P&Z #18-12000028 **Responses to December 28, 2020 Email**

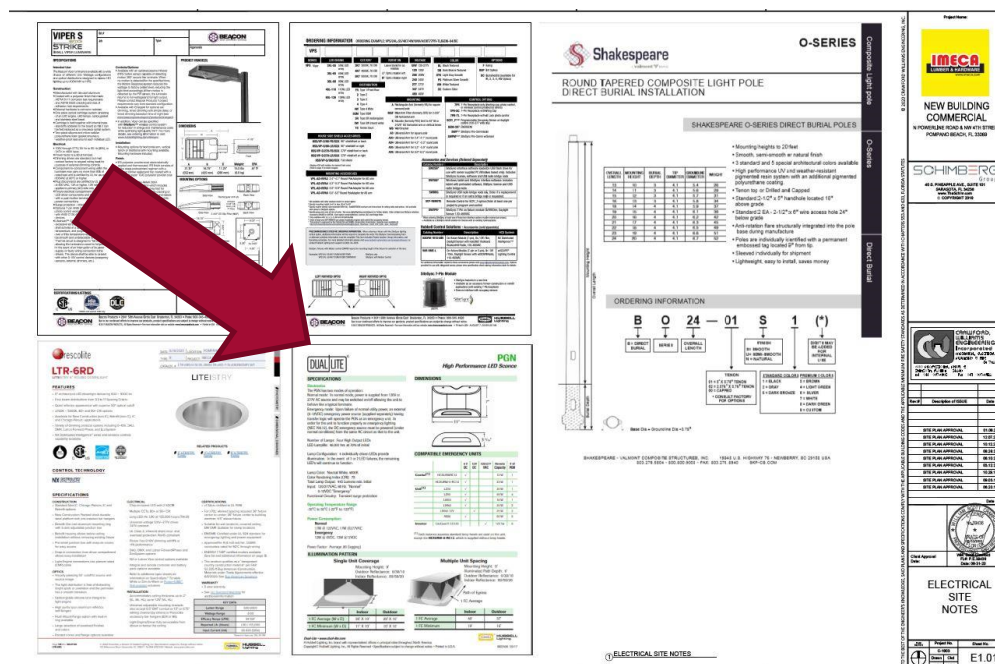
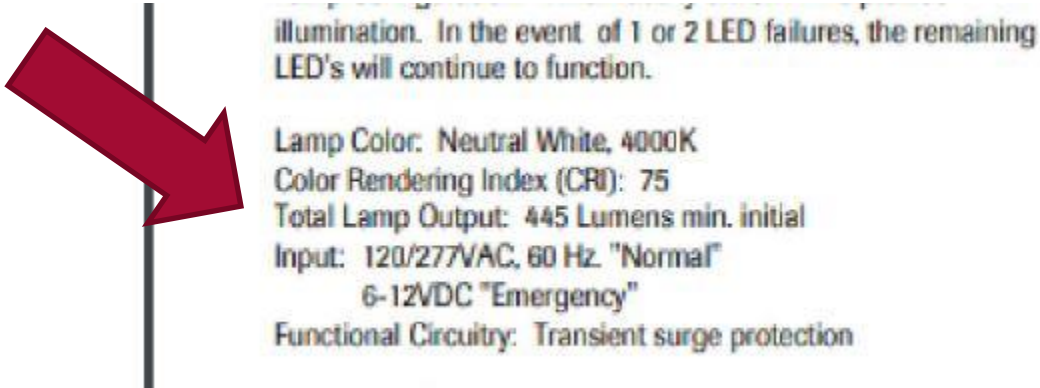
3. The cut sheet for the wall pack lighting fixture shows that it does not comply with 155.5401. The lumens range is 3,200-11,000. A maximum of 900 lumens is permitted. Revise the fixture type and update the drawings as well. **The wall pack clearly reflects a maximum lumen output of 445. See clip below in terms of where to find that information.**

Within that detail please refer to the following section indicating 445 lumens.
